## 2008 Race Tip # 11 – Piston Installation

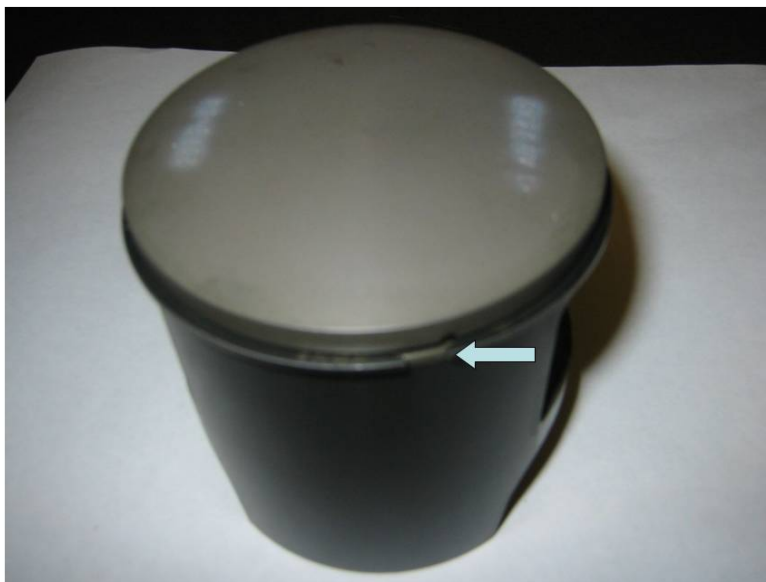
Some of the pistons P/N 2203611 may be incorrectly marked. The arrow on top of the piston may be pointing in the wrong direction.

***If the piston is installed incorrectly immediate engine damage will occur.***

To insure the piston is installed correctly, make sure the ring locating pin is on the intake side.
